URGENT FIELD SAFETY NOTICE
MEDICAL DEVICE CORRECTION
FSCAs 2249723-06/02/2023-010-C, 2249723-06/02/2023-011-C,
2249723-06/02/2023-013-C & 2249723-06/02/2023-014-C
Datascope Cardiosave Hybrid and Rescue Intra-Aortic Balloon Pumps (IABP)

Product Description:	Product Code/Part Number:	UDI Code:
Cardiosave Hybrid	0998-00-0800-31 0998-UC-0800-31	10607567109053 N/A
Cardiosave Hybrid	0998-00-0800-32	10607567111117
Cardiosave Hybrid	0998-00-0800-33 0998-UC-0800-33	10607567109008 N/A
Cardiosave Hybrid	0998-00-0800-34	10607567111940
Cardiosave Hybrid	0998-00-0800-35	10607567109107
Cardiosave Hybrid	0998-00-0800-45	10607567108421
Cardiosave Hybrid	0998-00-0800-52 0998-UC-0800-52	10607567108438 N/A
Cardiosave Hybrid	0998-00-0800-53 0998-UC-0800-53	10607567108391 N/A
Cardiosave Hybrid	0998-00-0800-55 0998-UC-0800-55	10607567108414 N/A
Cardiosave Hybrid	0998-00-0800-65	10607567113432
Cardiosave Rescue	0998-00-0800-75	10607567112312
Cardiosave Rescue	0998-00-0800-83	10607567108407
Cardiosave Rescue	0998-00-0800-85	10607567113449

Figure 2-5: Grasping the Fiber-Optic sensor connector

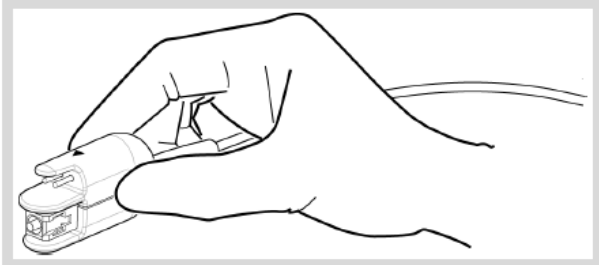
The Fiber Optic connector is designed to fit smoothly into the IAB Sensor Input. The red triangle on the top of the connector should align with the red triangle on the Cardiosave console. Inserting the Fiber Optic connector into the port without verifying the correct alignment can lead to internal damage. If difficulty is encountered when inserting the connector, verify that the connector is in the correct position and attempt to reinsert into the IAB Sensor Input.

Excessive force can cause damage to the connector and the internal fiber optic assembly of the IABP console. This may cause a disruption in the fiber optic signal acquisition resulting in an inability to acquire a fiber optic signal on the Cardiosave IABP. Following proper insertion procedures will minimize the potential for damage to the connector and a loss of signal. This conclusion is based on field observations seen through the complaints evaluation. As part of Datascope's investigation testing will be performed to confirm this observation.

1. With one hand, grasp the Fiber-Optic Sensor Connector as shown in Grasping the Fiber-Optic sensor connector, with the red triangle visible on top.

2. Remove and discard the protective cover from the Fiber-Optic IAB connector. Do not touch the exposed end of the Fiber-Optic cable.
3. With the other hand, open the protective shutter that covers the opening for the IAB Sensor Input (item 11, section 1.5.1) by rotating it to the left.
4. Insert the Fiber-Optic IAB connector into the IAB Sensor Input until it “clicks”.

Note:
Ensure that the red triangles on the Fiber-Optic IAB Sensor Connector and on the back panel are in alignment.

In step 4, when the Fiber-Optic connector is inserted into the IAB Sensor input until an audible “click” is confirmed, ensure that you are not using excessive force as that can lead to damage to the Cardiosave.
